STAFF REPORT

Case #18-23: SPECIAL PERMIT

330-332 Hathaway Blvd. Map: 82 Lot: 225

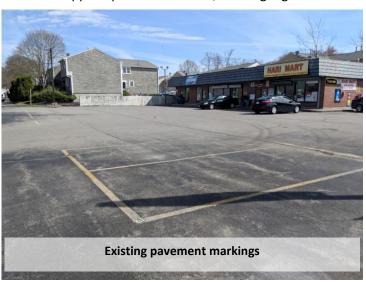
A note on plans submitted and proposed parking. There is a discrepancy between the application and site plan submitted. The applicant has noted that thirty (30) spaces are proposed, which is the same as the existing conditions. The board may wish to clarify with the applicant whether or not the three (3) additional spaces will be added along the Hathaway Boulevard frontage as shown on the plans submitted. If the applicant is not adding the three (3) spaces in this area, revised plans should be submitted for the case file.
